Planning Officer Report

183-189 A'Beckett Street, Melbourne

Planning Permit Application 2015/035725

Figure 3- Approved buildings within the vicinity of the site

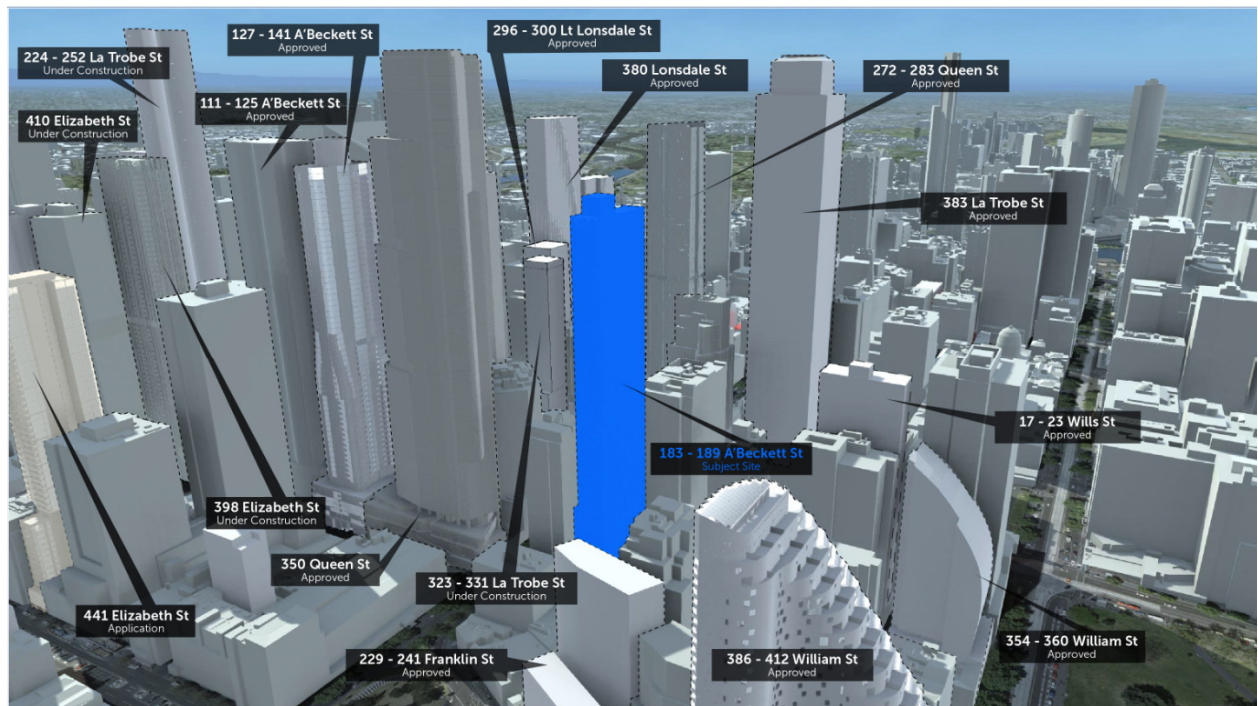
Above the podium, the proposed tower will have a maximum height of 177.3m (overall 200.5m AHD including plant). The overall building height of the development is considered to be contextually appropriate and consistent with the emerging character of the surrounding area. The proposed height is commensurate with the heights of buildings being constructed and approved in the surrounding precinct, including the developments at 350 Queen Street, 383 La Trobe Street, 316-322 Queen Street, 111-125 A'Beckett Street and 450 Elizabeth Street. The site is not affected by any height controls and the proposed height of 177.3m is considered to be acceptable. Refer to Figure 3.

Figure 4- Detailed sections – Heritage interface

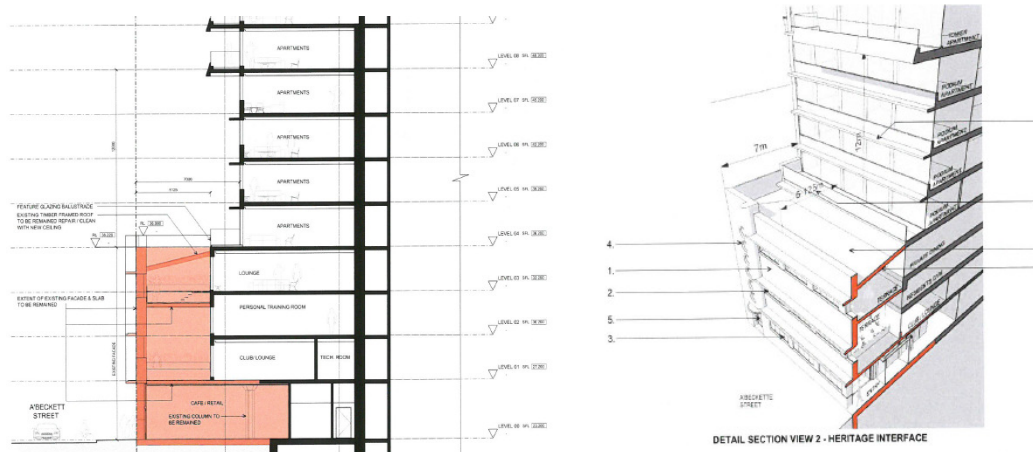
The existing heritage building is identified as a 'B' graded building in the Melbourne City Council's Heritage Places Inventory (2008) and the Central City Heritage Review (2011). Clause 22.04 – Heritage Places within the Capital City Zone and Clause 43.01 – Heritage Overlay set out guidelines which seek to ensure that new development does not undermine the significance of any heritage place and that the visual prominence of a heritage building is maintained. Following the recommendation made by Council's Planning Committee, the proposal was informally amended to allow the original façade to a depth of 10.3m and the western wall up to 14.2m to be retained including the existing internal building columns. In response to the plans, Melbourne City Council's

planning officer noted that “the proposed changes particularly in relation to the heritage matter are an improvement from that originally considered”. However Council’s Heritage Advisor recommended “that the western side boundary wall of the existing building be retained to the depth of the first saw-tooth roof bay”, i.e. an additional 6.4m.

Although tall buildings generally have a podium height of between 35 to 40m, the proposed 13.79m podium in this instance is consistent with the standard encouraged by Clause 22.01, which acknowledges a need to provide context for a heritage building. Above the podium, the tower will be setback 6m from A’Beckett Street, from levels 4 to 27 and then 7m from levels 28 to the top of the building. From Level 4 the tower will include the following setbacks: 5m to the middle of the lane (west), 5m to the rear (south) and from 0 to 3m to 5m along the eastern boundary.

Figure 5- Floorplan showing eastern boundary setbacks

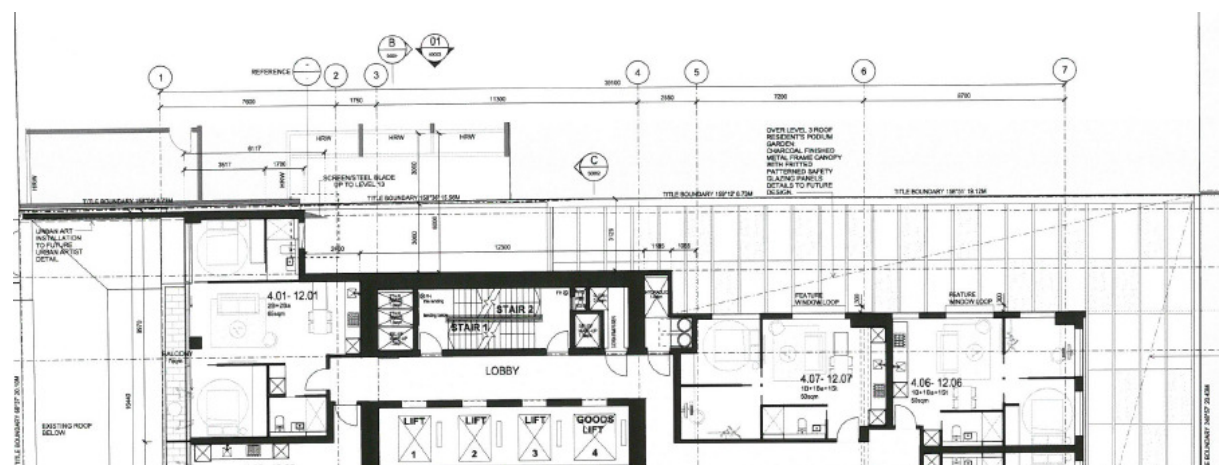
- The 5m setback provided from the side and rear boundaries does not provide for equitable development rights, adequate tower separation or acceptable amenity outcomes.

- East: The tower will be setback 0 to 3m and then 5m from the eastern boundary which it shares with 175-181 A'Beckett Street and 341 Queen Street. The site at 175-181 contains apartments with habitable room windows setback approximately 3m from the common boundary and balconies located within this setback. Although a 6m separation would usually not be considered appropriate, given that there are no windows directly facing the existing apartments, it is considered acceptable in this instance as overlooking will not occur and the building at 175-181 A'Beckett Street is unlikely to be redeveloped in the future. In the instance that 341 Queen Street is redeveloped in the future, in line with the current Amendment C270 controls, the proposal would be required to provide a minimum building separation of 10m.

- Equitable development rights: Although council's planning officer considers that a 5 metre setback from the boundaries would impact on the development potential of adjoining land, should any of these sites be redeveloped in future they would also be required to setback any tower a minimum of 5m or more in accordance with Amendment C270, which is considered to be acceptable.

Figure 6- Overshadowing diagrams (22 September)

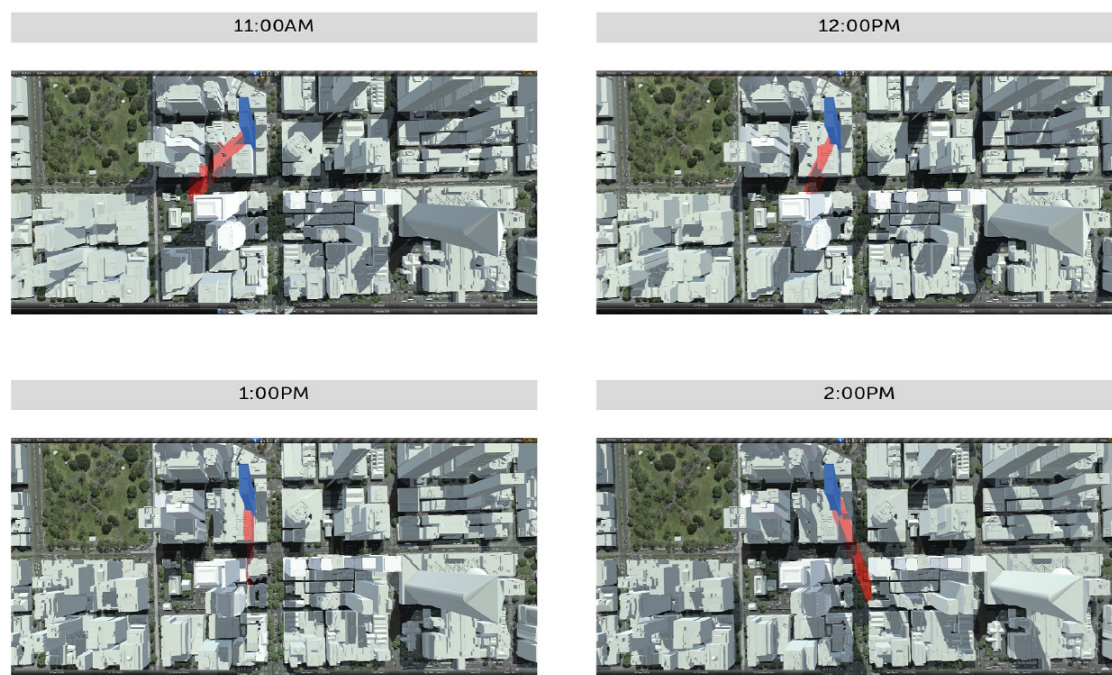
Clause 22.02 'Sunlight to Public Spaces' states that development should not reduce the amenity of public spaces by casting any additional shadows on public parks and gardens, public squares, major pedestrian routes including streets and lanes (including all streets within the retail core of the Capital City Zone), and privately owned plazas accessible to the public between 11.00am and 2.00pm on 22 September. The shadow diagrams were tested by the Department and it was found that some overshadowing will occur to La Trobe and Queen Streets. The shadows are not considered to be significant in their extent nor would they substantially reduce the amenity of these spaces and are therefore considered to be acceptable. The proposal will not overshadow any public parks, gardens or public squares between 11.00am and 2.00pm on 22 September.
